## Planning Commission Staff Report

July 23, 2014  
Item 6.a.

- SUBJECT:** Work Session for P14-0924 (Specific Plan Amendment) and PUD-106
- APPLICANT:** John Gutknecht, Habitec Architecture
- PROPERTY OWNER:** Alameda County Surplus Property Authority

**Figure 3: Proposed Site Plan**

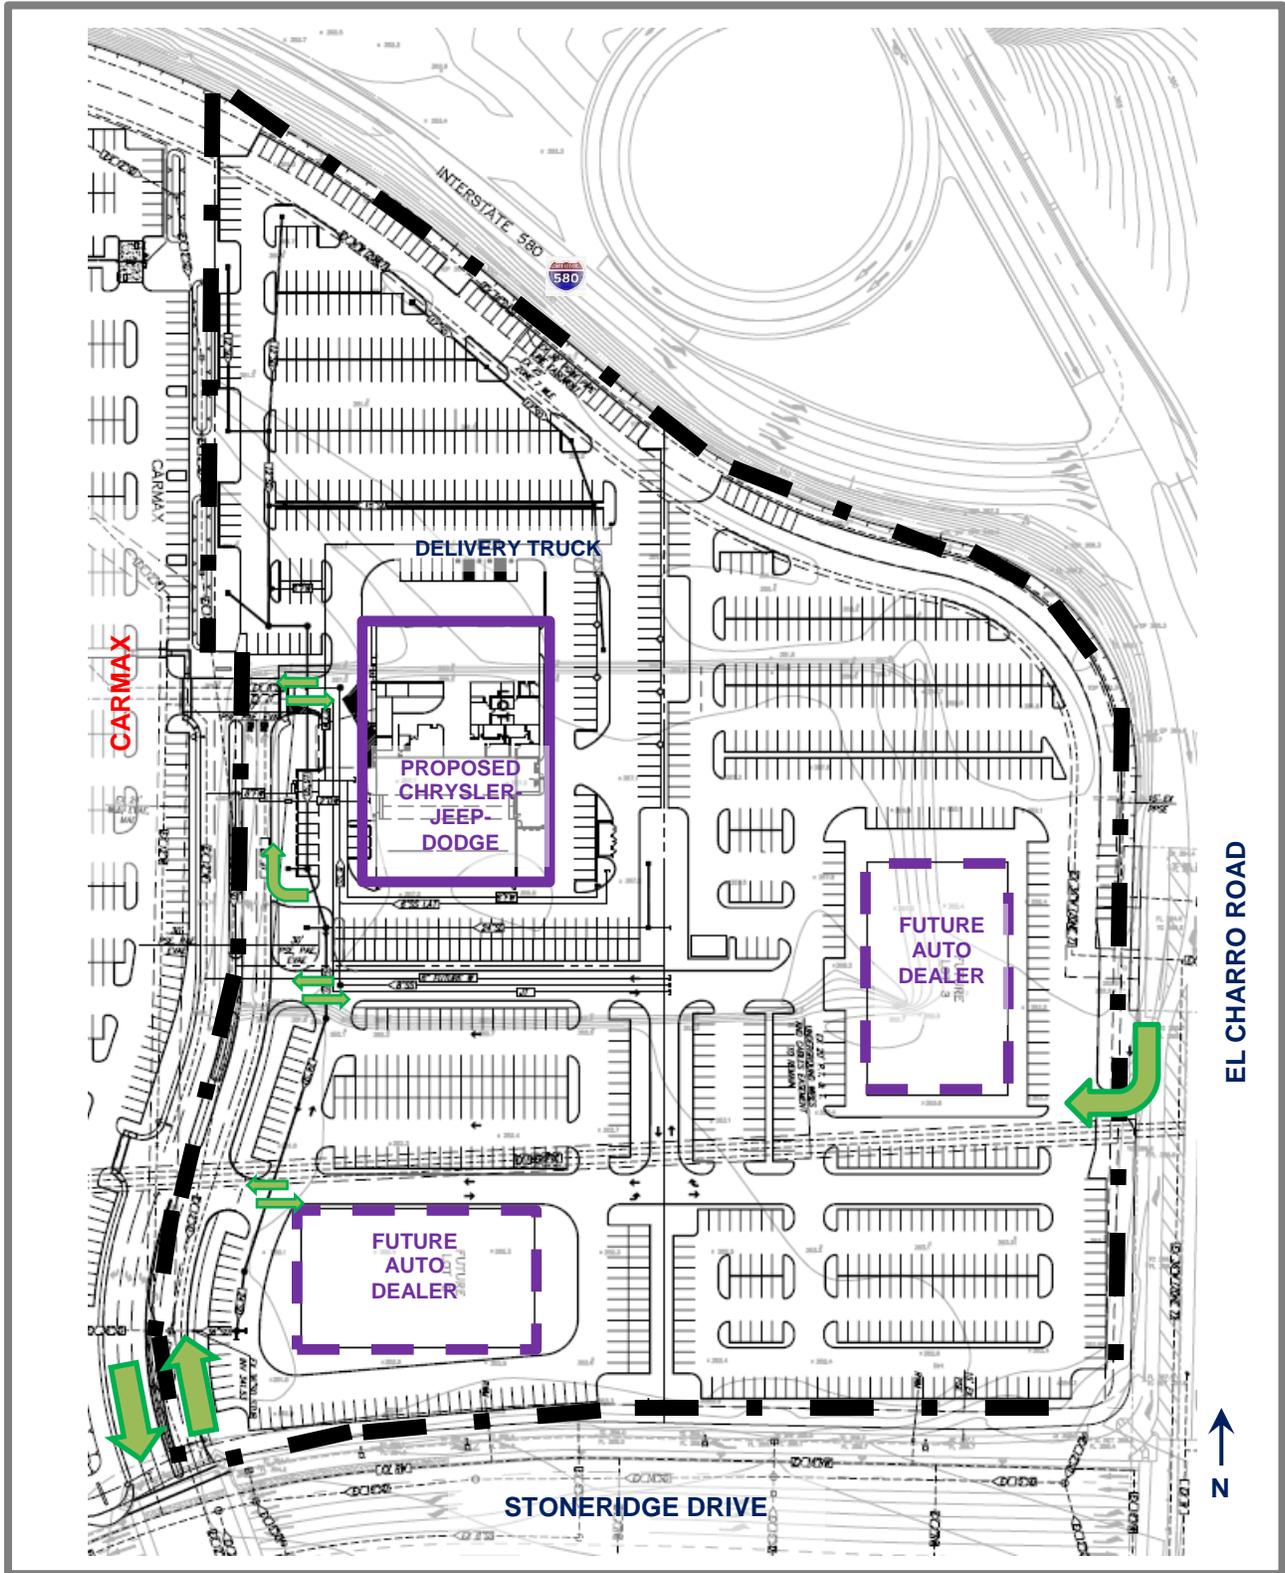
A. **Site Plan and Project Layout:** The applicant has the option to acquire the entire 16-acre site, but immediate plans are to develop only 5 acres for the proposed Chrysler-Jeep-Dodge dealership. However, staff is requiring an accurate and detailed site plan that includes the entire 16-acre site to ensure that the on-site circulation system, including areas for unloading of vehicles, and other related items, are designed comprehensively in a way that is acceptable to the City.

As mentioned above, the proposed 5-acre Chrysler-Jeep-Dodge site would be accessed by a right-turn from the shared entry drive. As currently shown, no cross access is proposed between the proposed 5-acre site and the remaining 11 acres, except for an egress-only aisle between the subject site and the future lot to the south (Lot 2). However, staff is requesting an additional access point between Lots 1 and 2, and an egress-only access aisle to be constructed with the project.

A delivery area for trucks is proposed near the northeastern corner of the proposed building, in the drive aisle separating the visitor parking from the display parking area, and is noted in Figure 3.

The visitor and employee parking areas will have trees and shrubs in landscape fingers and diamond planters. Due to concerns regarding leaf and fruit litter, no landscape diamonds with trees are proposed within the parking stalls in the display area. Staff has requested the applicant incorporate trees within the planters located at the end of the drive aisles in the display area.
